January 5, 2026

First Covenant Church Lobby & Fellowship Addition – JGR Proj #25-3518

ADDENDUM NO. 2

E

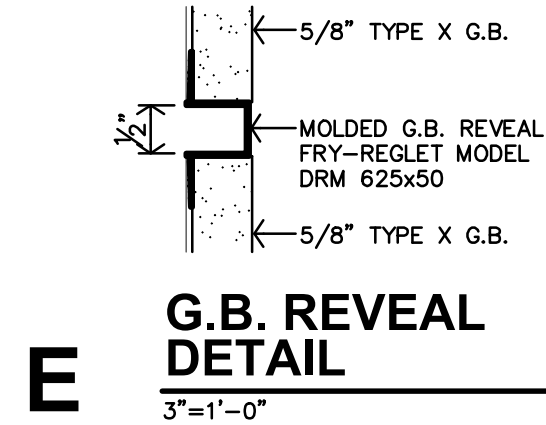
2. Sheet A3.2 – Detail D – Clarification – The BASE BID at the fireplace shall be drywall with reveal joints as shown on this detail. **Alternate 3 shall include the wood wall paneling per B/A6.1**

A BUILDING SECTION
1/4"=1'-0"

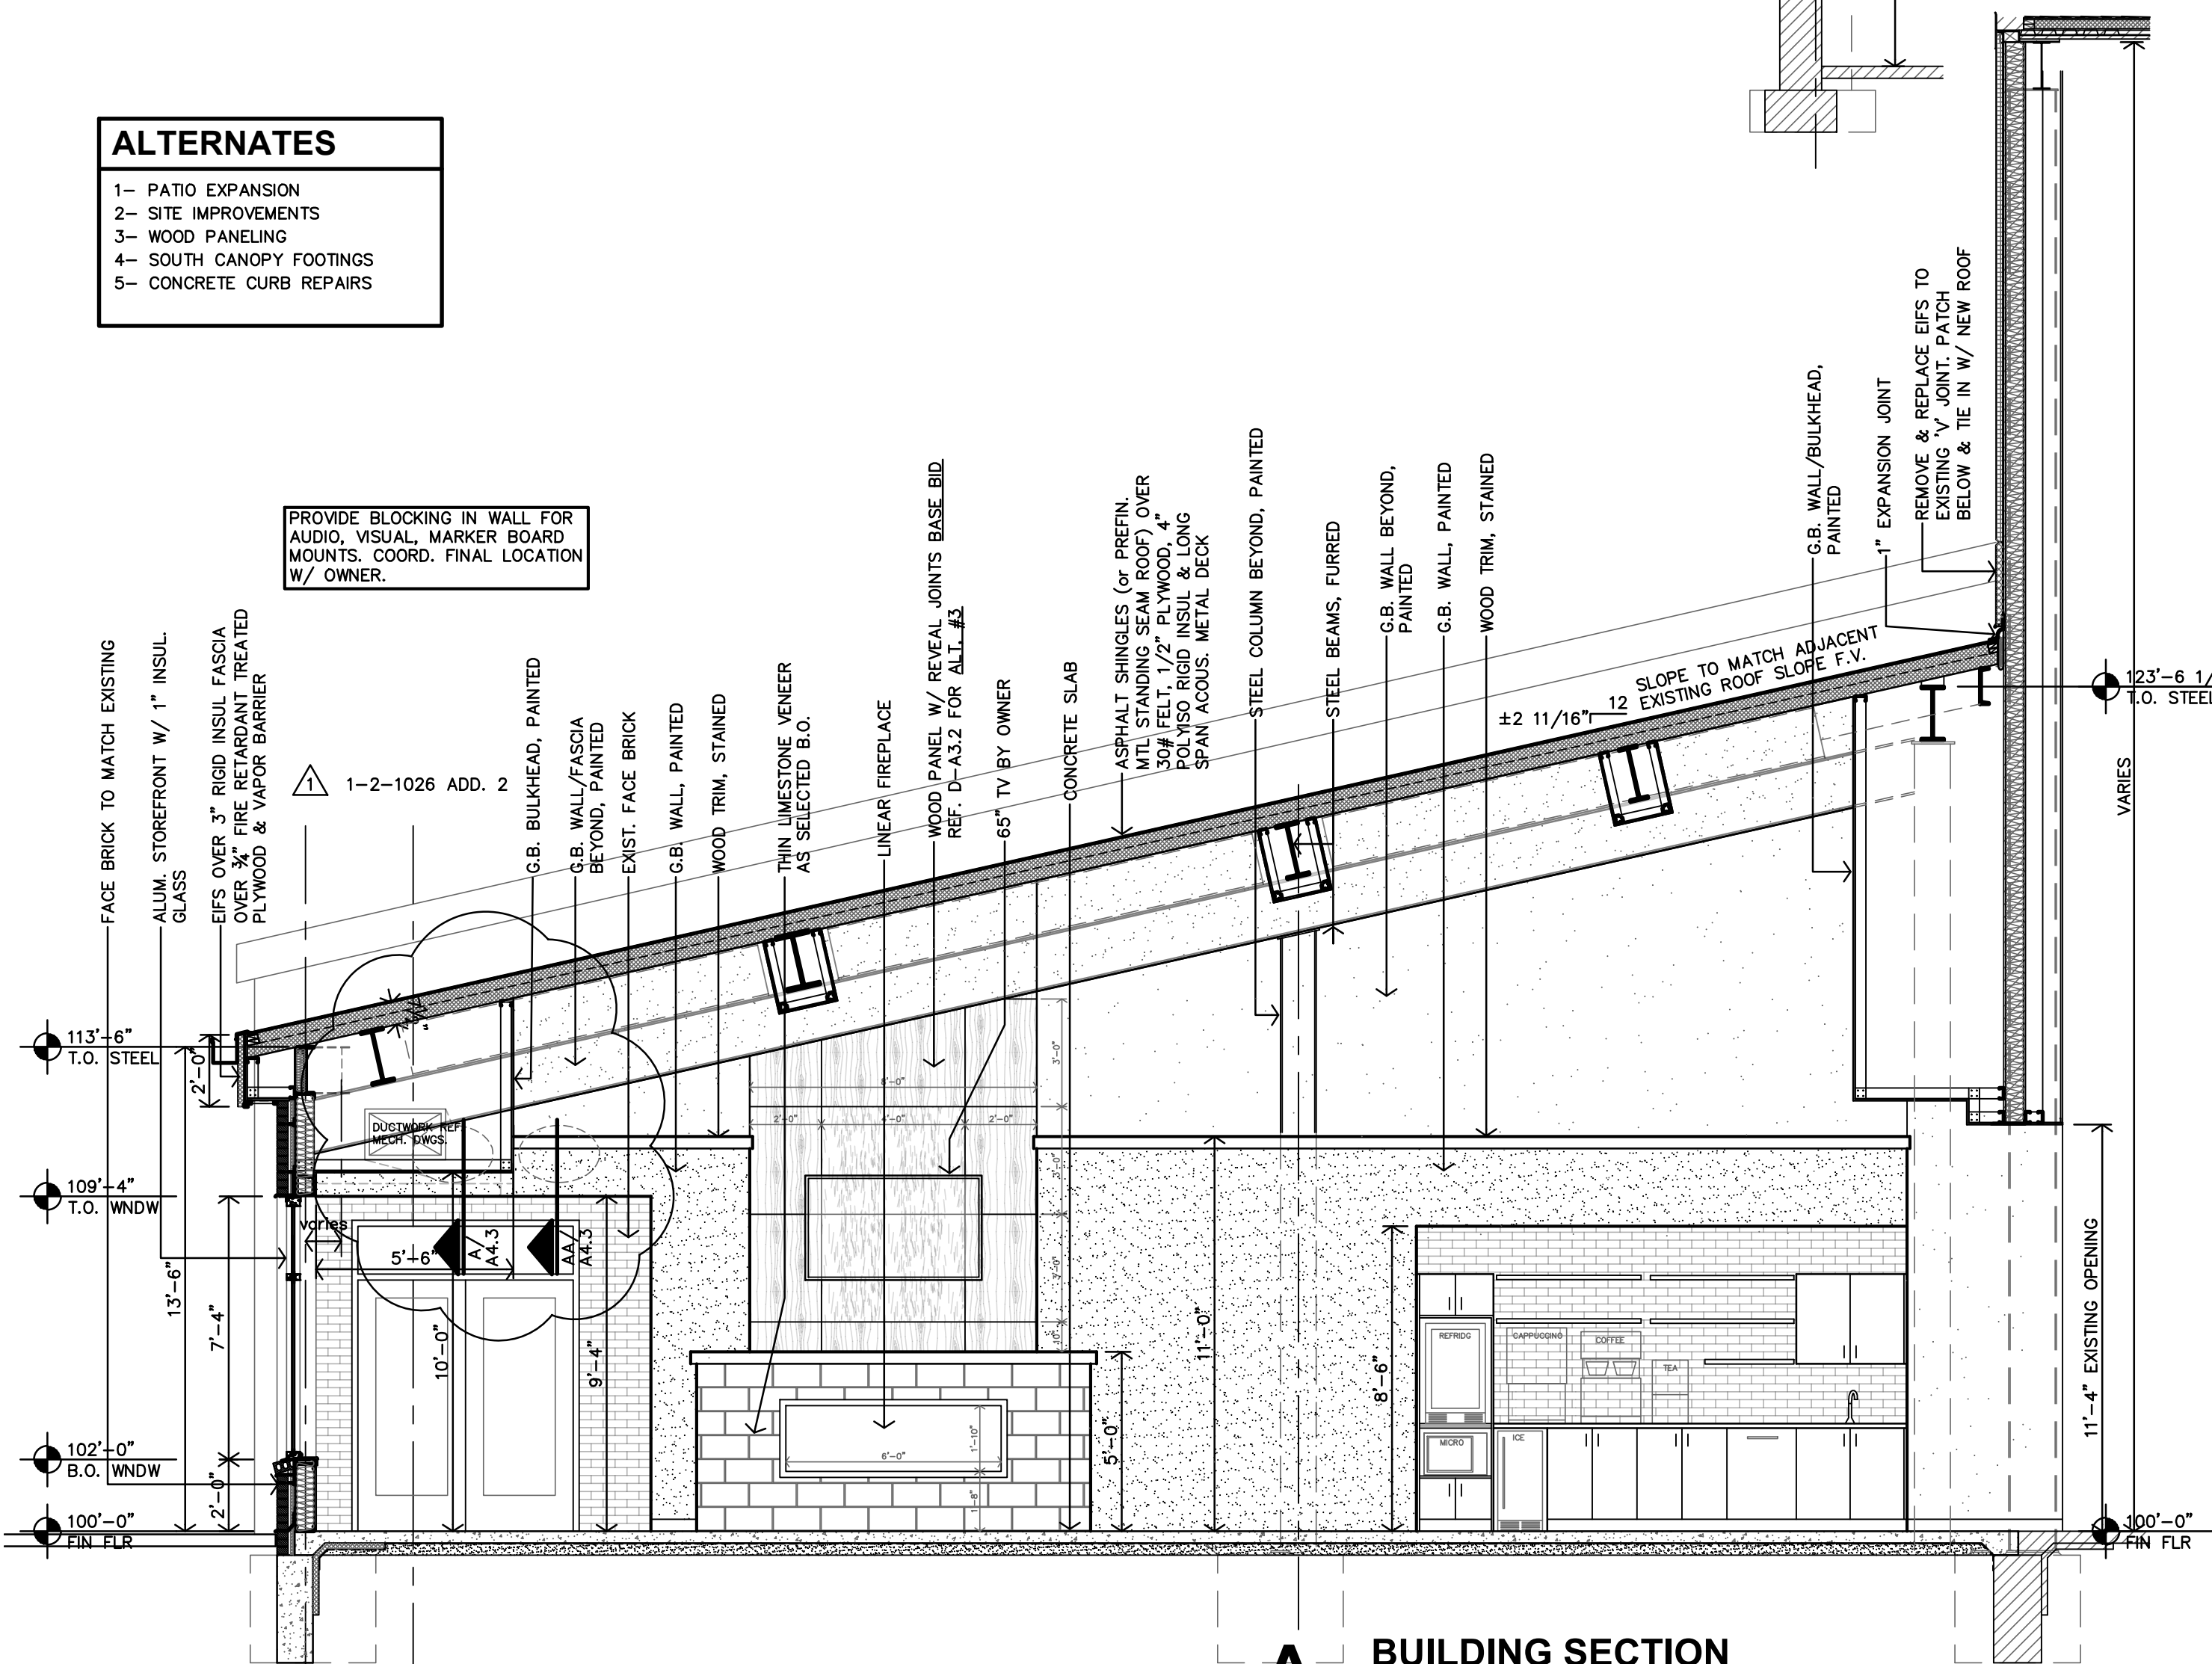
1. Sheet A3.2 – Building Section A – Reference revised drawing sheet attached with this addendum for clarification regarding ductwork penetration and transition at the NW corner wall penetration.
